REQUEST FOR INFORMATION

PROJECT	:	CADANGAN PEMBINAAN BALAI BOMBA DAN PENYELAMAT BEAUFORT SABAH					
ISSUED TO	:	Noor Izwan Arkitek			ISSUED DATE	:	6-Jun-21
ATTENTION	:	Ar. Noor Izwan Rahim			RF Info No.	:	RF Info/BOMBA/ARC/07
DESIGNATION	:	Principal					
C.C	:	Aktif FA Konsult					
This RFI will Constitute	**:**		**Variation Oder**		**Time Extension**		**N/A** **PIC Siganture** _____
INFORMATION REQUIRED	:	Blok Utama					
1)Design for Hood at Ruang Jentera Opening							
2) Please specify material use.							
3) Please specify top level of the hood from ground floor level, Roller shutter size 4550 (height) x 5000 (length)							
* Please refer attachment for detail.							
Date Required	:						
ISSUED BY Name	:	Sulastri			Designation	:	QAQC

1. RUANG JENTERA

ARCHITECT DRAWING NO.: *NIA1902/KPKT/BB/BS/CD-10(BU)*

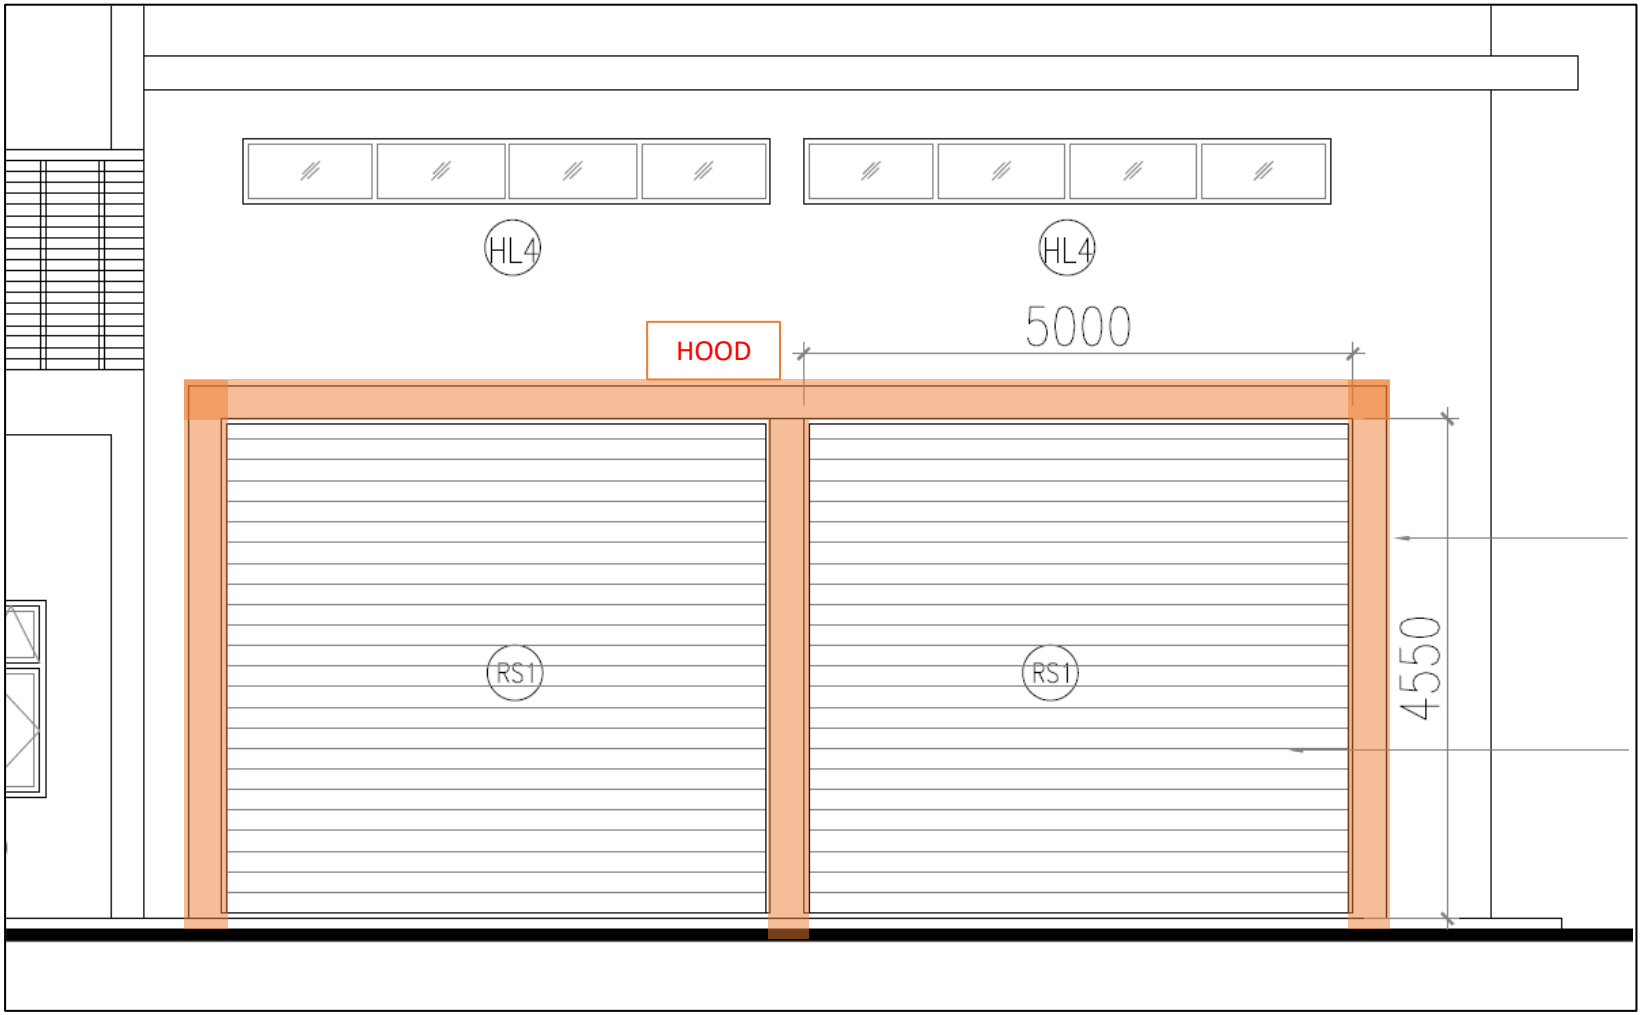
DESIGN FOR HOOD AT RUANG JENTERA OPENING:

- PLEASE SPECIFY MATERIAL USE
- PLEASE SPECIFY TOP LEVEL OF THE HOOD FROM GROUND FLOOR LEVEL; ROLLER SHUTTER SIZE 4550 (HEIGHT) X 5000 (LENGTH)
